Spoken Testimony on 145th Street Station Subarea DEIS Addendum

Attachment J - Comments on Addendum to DEIS

Subject: Additional Comment on 145th Addendum to DEIS

Figure 7: Paramount Park Wetlands and Streams Mapping. Otak 2015

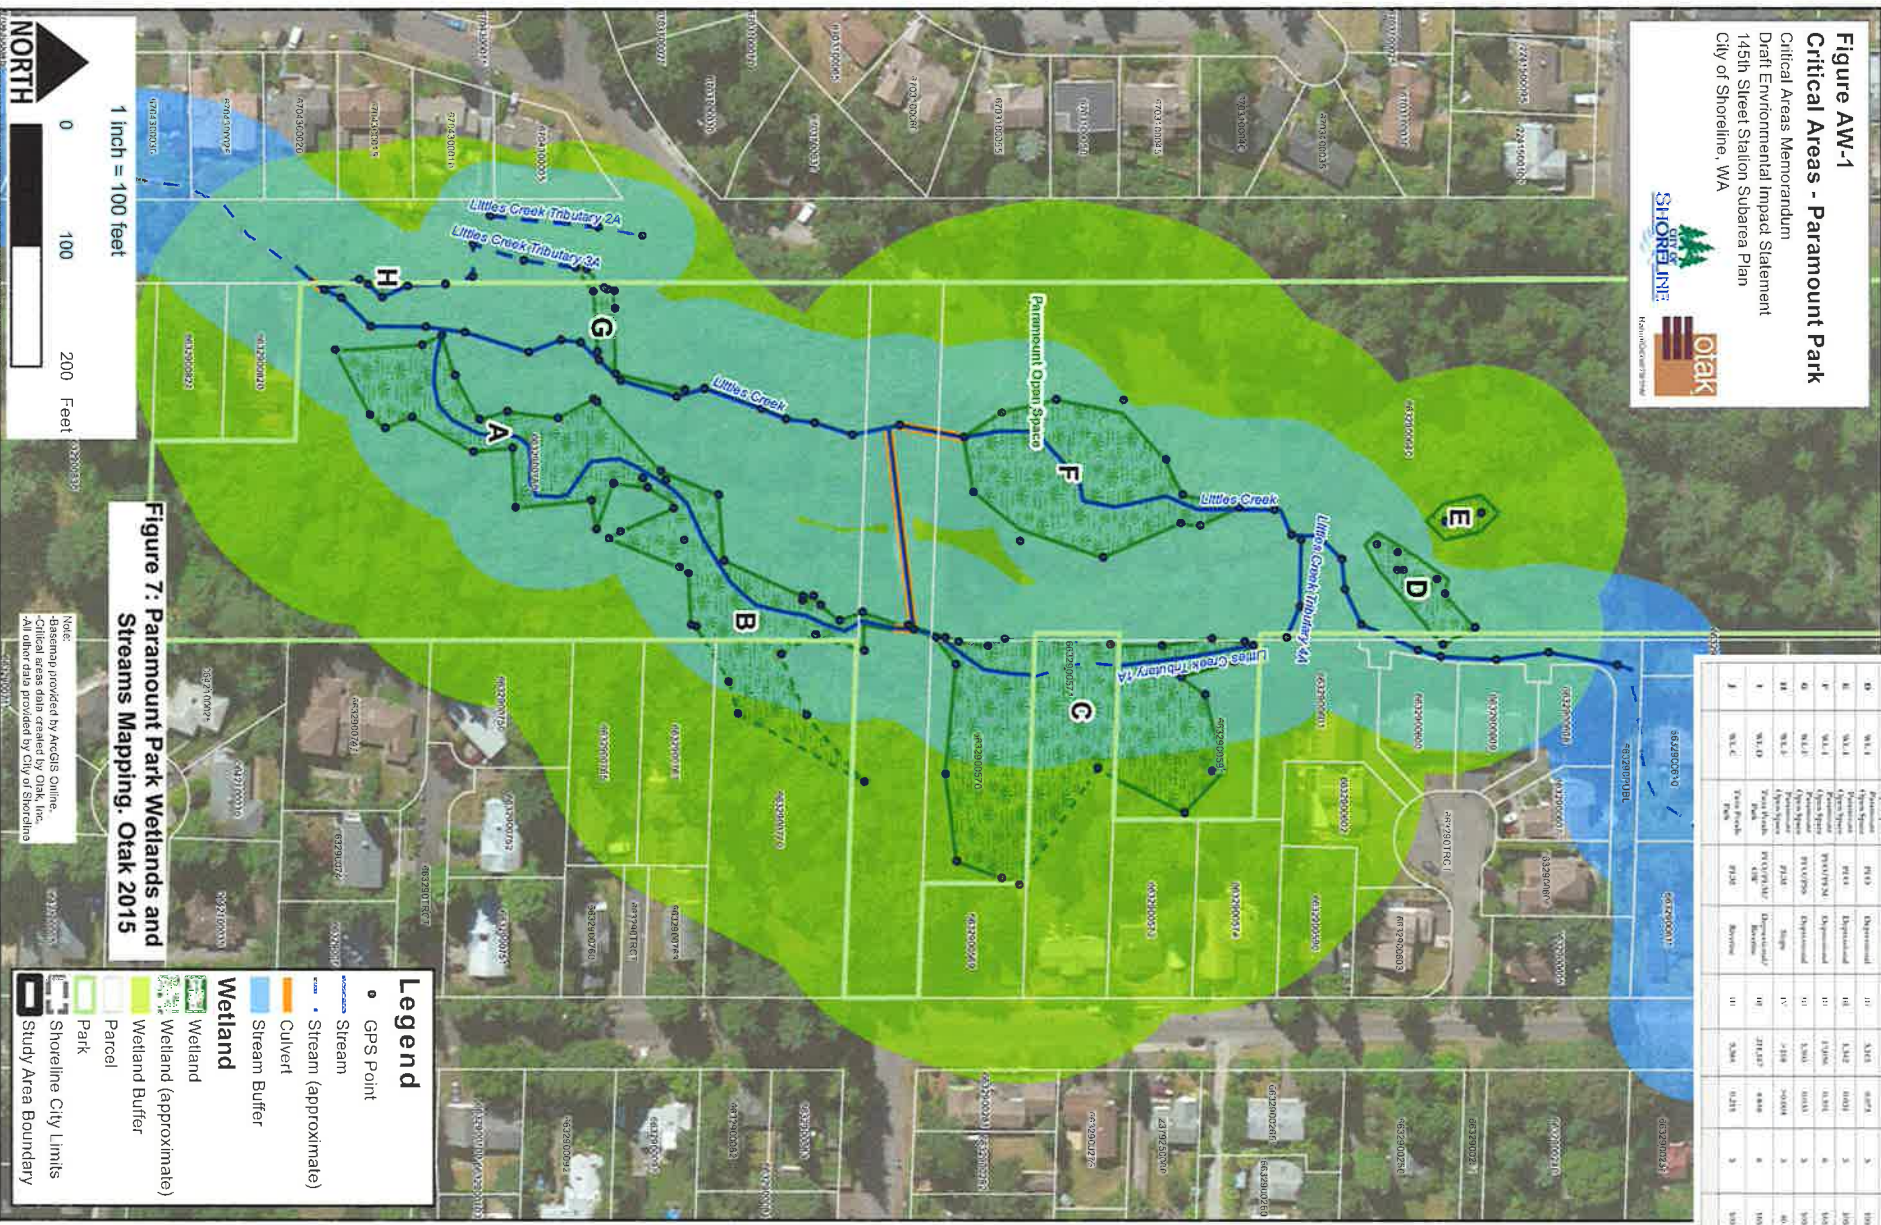
The Otak reconnaissance wetland map is also displayed as a layer on the City's Wetland map as a layer that is shown as either a blue or yellow polygon/series of polygons on Figure 6. as the with Wetland III having a much reduced footprint of wetland WL-I and the red pattern with a much reduced footprint over the previous delineation also shown as the blue shaded pattern on Figure 6.

The wetland ratings listed in the Otak reconnaissance from August and September 2015 were all listed as Category III and IV wetlands (see table at top of Figure 7), while the City's wetland inventory reports 4 Category (type) II wetlands and 5 category (type) III wetlands within the Park and three Category (type) II wetlands and 1 Category (type) III wetland just adjacent to the Park. While I did not rate the wetlands during my site evaluation it should be noted that I sat on the team that developed the 1992 wetland rating and I was a technical reviewer and taught the method for the Department of Ecology for the subsequent version (2004 updated in 2008) used for this analysis and I find it unlikely that some of the forested wetlands I saw out in the Park would be less than a Category II wetland rating. The rating should be revisited when a formal delineation is performed because the buffer widths proposed could possibly change as a result of the ratings changing from a Category III to a Category II wetland. This would obviously affect the development footprint on the lots just adjacent to, or including the wetlands that would be a Category II type. The buffer widths assigned to the

The drainages (streams and creeks) mapped in the Park by Otak (Figures 6 and 7) include some omissions that have been added back as the black lines on the City's GIS database (Figure 6). We observed these creeks/drainages are still present when we performed our reconnaissance on January 29th, 2016 (Photos P8, P9, P11, P17, P20, P23, P24, P21, and P25). Little's Creek is the main tributary to Thornton Creek through the park but there are many other tributaries, wetlands, ponds and connecting channels that are also present (See Figures 5 and 6). Some of the channels are now piped, especially the main channel that passes through a culvert under the gravel road the bisects the Park from north to south (photo P17).
